Crystal River Nuclear Plant
Docket No. 50-302
Operating License No. DPR-72

April 13, 2007
3F0407-12

Subject: Crystal River Unit 3 – License Amendment Request #295, Revision 0,
Extension of Allowed Outage Time to Seven Days and Elimination of Second
Completion Times Limiting Time

Figure 1

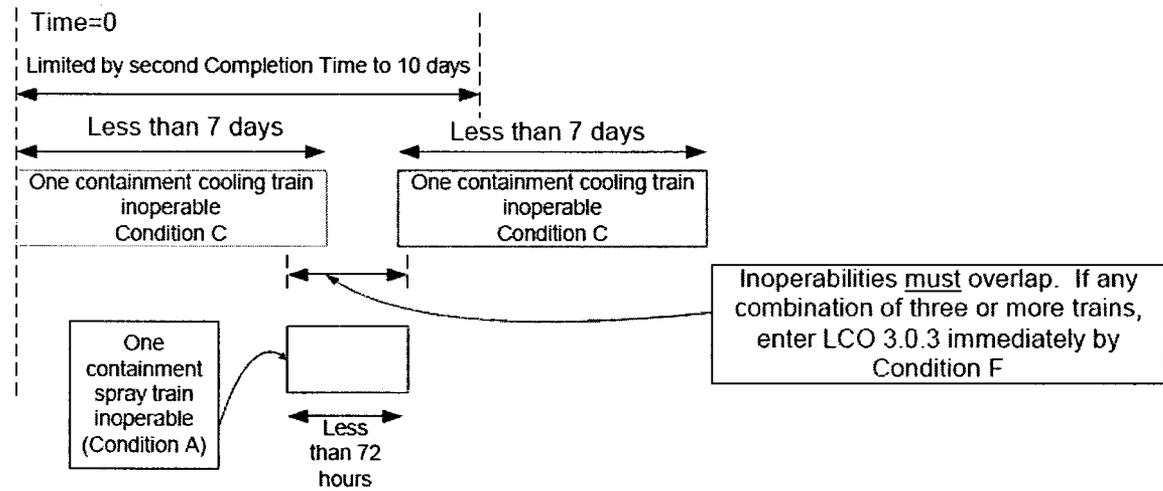
CR-3 ITS 3.6.6, Reactor Building Spray and Containment Cooling Systems, currently has a 72 hour Completion Time for one BS train inoperable (Condition A) and a seven day Completion Time for one required Containment Cooling train inoperable (Condition C). Conditions A and C have a second Completion Time of ten days from discovery of failure to meet the LCO. Below, Figure 1 shows how these Completion Times relate to each other. In the figure, containment spray train refers to BS train.

The second Completion Time (the ten days) is not needed. Condition F of CR-3 ITS 3.6.6 states that if two BS trains are inoperable or any combination of three or more trains is inoperable, LCO 3.0.3 must be entered immediately. Therefore, any combination of two of the four trains can perform the safety function. The second Completion Time restricts operation with only one train inoperable, but that is unnecessary because when one train is inoperable, there are still three operable trains and only two are needed to perform the safety function. Therefore, the second Completion Time is overly restrictive.

Figure 2

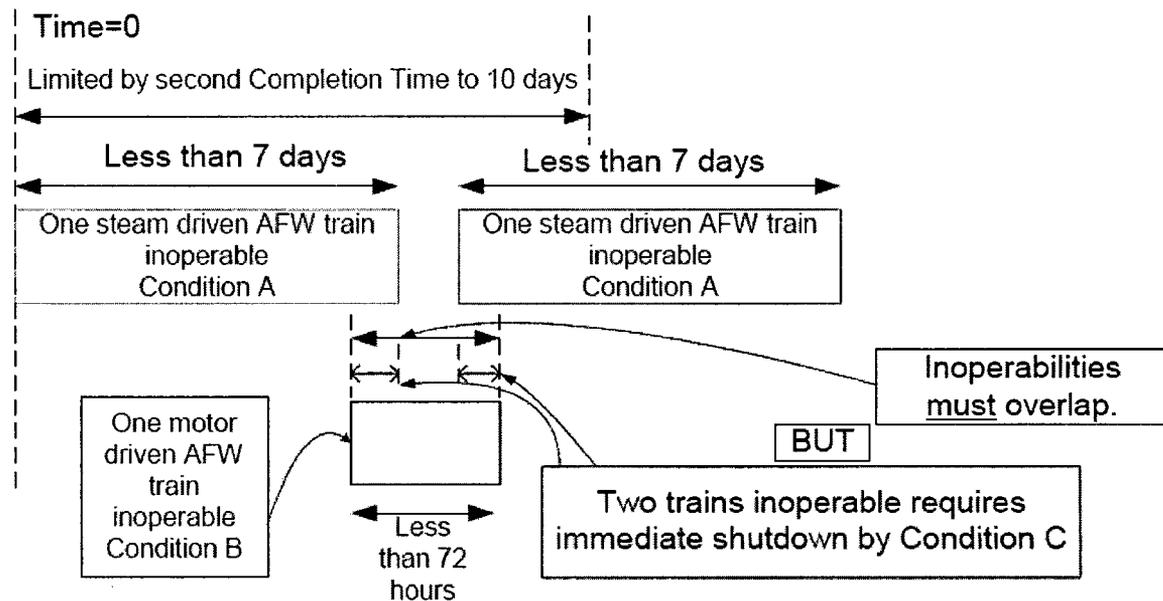
CR-3 ITS 3.7.5, EFW, has a seven day Completion Time for one inoperable steam supply to a turbine driven EFW pump (Condition A) and a 72 hour Completion Time for one EFW train inoperable for reasons other than Condition A (Condition B). Conditions A and B have a second Completion Time of ten days from discovery of failure to meet the LCO. In order for the second Completion Time to be limiting, entry into and out of Conditions A and B must occur, which requires the turbine driven and motor driven EFW

pumps to be concurrently inoperable. Below, Figure 2 shows how these Completion Times relate to each other. In the figure, AFW refers to the CR-3 EFW System.

The second Completion Time is not needed. Condition C states that if either EFW train is inoperable, the plant must be in Mode 3 in 6 hours and Mode 4 in 12 hours. For the second Completion Time to be limiting, Conditions A and B must be entered concurrently. However, Condition C requires the plant to initiate action immediately to restore one of the EFW trains to operable. Having failed this, necessary for the second Completion Time to be in effect, the plant must enter LCO 3.0.3. The second Completion Time will never be more limiting than LCO 3.0.3 and therefore can be removed. In addition, the ROP monitors the availability of the EFW System. Such frequent, repeated failures of the EFW System would be reported to the NRC, and this represents a strong disincentive to such operation.

Figure 3

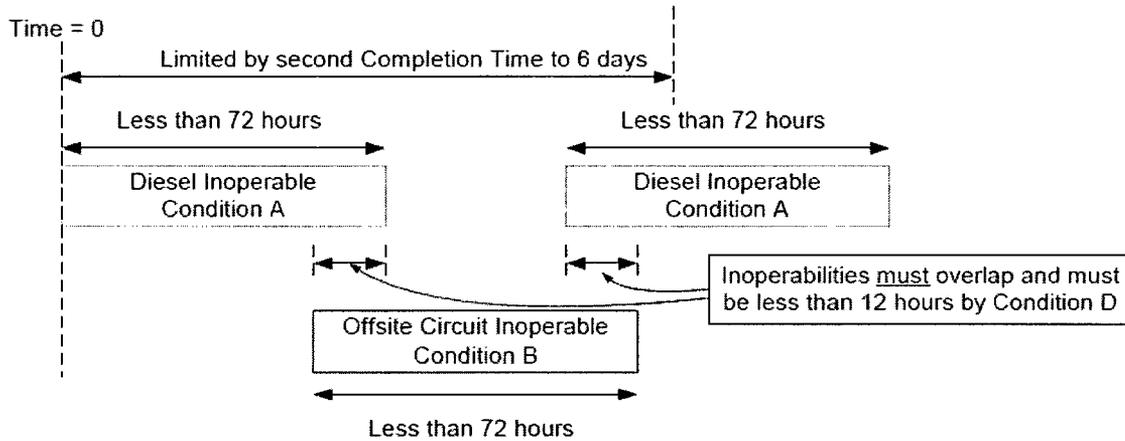
For the second Completion Time to be in effect, Condition A or B must be entered. For the second Completion Time to stay in effect, the other Condition must be entered before the first inoperable system is restored. Only then can the first inoperable system be restored. Again, for the second Completion Time to remain in effect, the first system

must be declared inoperable before the second system is restored. This highly improbable scenario is further limited by Condition D which applies when both a required offsite circuit and an EDG are inoperable. It limits plant operation in this Condition to 12 hours. Below, Figure 3 shows how these Completion Times relate to each other.

As previously stated, the ROP monitors the availability of mitigating systems, including Emergency AC sources (EDG unavailability). Such frequent, repeated failures of the AC sources would be reported to the NRC, and this represents a strong disincentive to such operation.

Figure 4

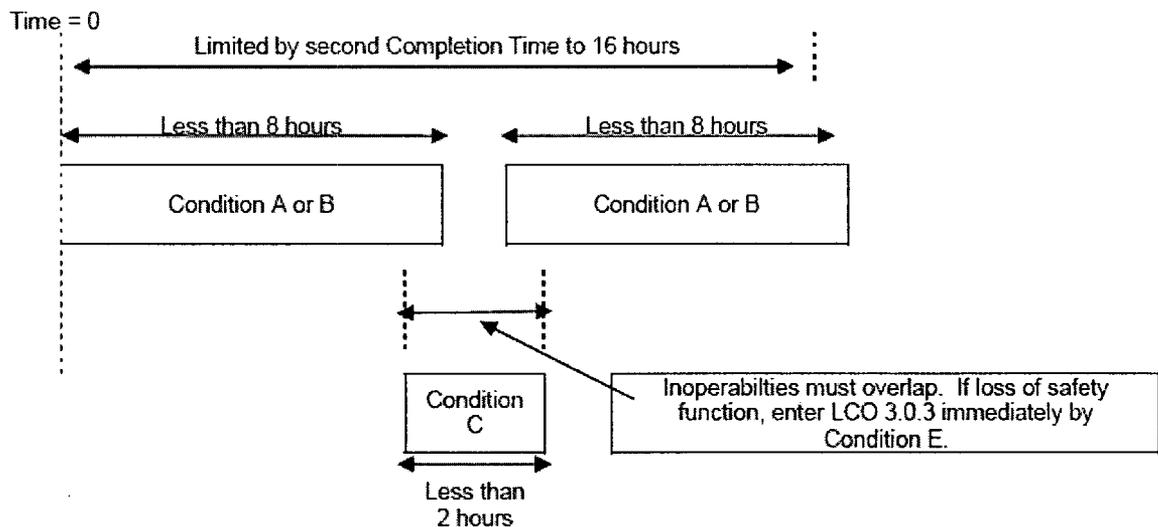
CR-3 ITS 3.8.9, Distribution Systems – Operating, has an eight hour Completion Time for one AC electrical power distribution subsystem inoperable (Condition A) or one AC vital bus subsystem inoperable (Condition B), and a two hour Completion Time for one DC electrical power distribution subsystem inoperable (Condition C). Conditions A, B and C each have a second Completion Time of “16 hours from discovery of failure to meet the LCO.” Condition E applies if two trains have inoperable distribution subsystems that result in a loss of function. In this condition, then LCO 3.0.3 must be entered immediately. Below, Figure 4 shows how these Completion Times relate to each other.

The second Completion Time is not even needed. These Completion Times are very short, two or eight hours. This provides little opportunity to restore systems such that Conditions overlap and multiple inoperabilities occur. Further, any overlapping inoperabilities that occur and result in a loss of safety function require a plant shutdown in accordance with LCO 3.0.3.
